APPEAL SUMMARY

Project Address: 1660 SE Spokane St
Appellant Name: BRANDON YODER
Appellant Phone: 5032523453
Plans Examiner/Inspector: Brian McCall
Stories: 4 Occupancy: R-2 Construction Type: V-A
Fire Sprinklers: Yes - Full NFPA 13
LUR or Permit Application No.: 18-173133-CO
Proposed use: Apartments

Appeal item 1

5 SOUTH (REAR) A1 1/8" = 1'-0"

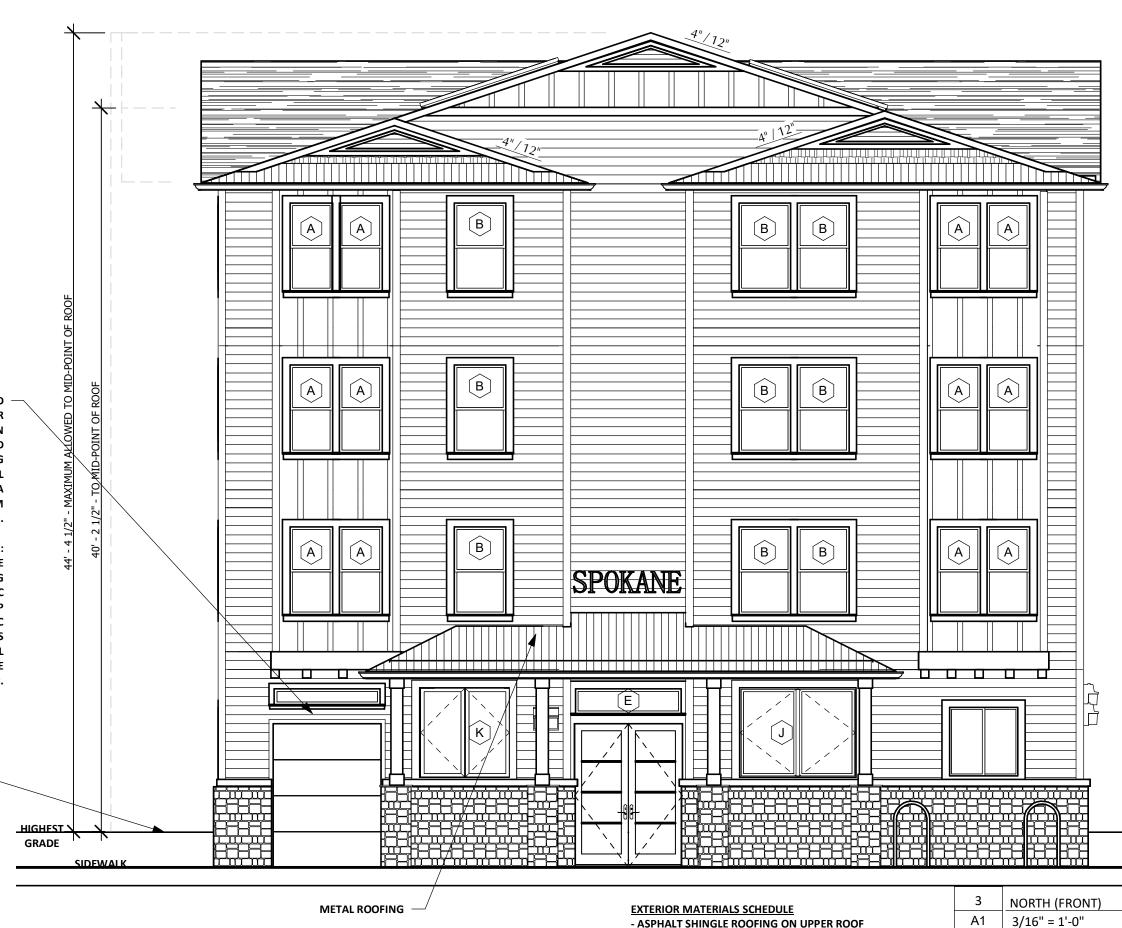
Code Section	705.8.6.2
Requires	705.8.6.2 Vertical Exposure for Buildings on separate lots
	When a new building is to be erected adjacent to an existing building, all openings in the exterior
	wall of the new building are required to be not less than 3?4 hour when these openings are less than
	15 feet vertically above the roof of the existing building or structure. The opening protections are
	required where the distance between the buildings or structures is less than 15 feet
Proposed Design	Proposed south and a portion of the east wall of new building will be provided with window washer sprinkler heads, instead of 3?4 hour opening protective. Provide fire sprinklers at interior, installed between 4" (min) and 24" (max)from windows, spaced at 6 feet on center max, sprinklers to be capable of wetting entire interior window surface. Entire building is sprinkled to the Full NFPA 13 system and is V-A construction.

Reason for alternative	The building is fully sprinkled to the full NFPA 13 system. All openings at this wall are compliant with table 705.8, regarding allowable opening area relative to the entire wall area. Entire wall length is 1-hour fire rated. The new south wall is adjacent to an existing wall on the south adjacent property, the building on the south adjacent lot is a type III-B concrete building with a parapet.
	The new east wall is adjacent to a two buildings, an existing wood framed garage & a pre- manufactured metal building, on the east adjacent property.
	The windows into the units at this area will provide much needed natural ventilation and light and are important to provide a healthy living environment.

Type 13 water curtain sprinkler protection at non-fire rated openings in buildings with vertical exposure on separate lots: Granted provided windows are non-operable and sprinklers are spaced not more than 6 feet apart and placed a minimum of 6 inches and a maximum of 12 inches from the opening(s) and a maximum of 12 inches below the ceiling. Sprinklers are to be installed on the occupied side of the openings.

Note: This decision doesn't grant any mechanical openings.
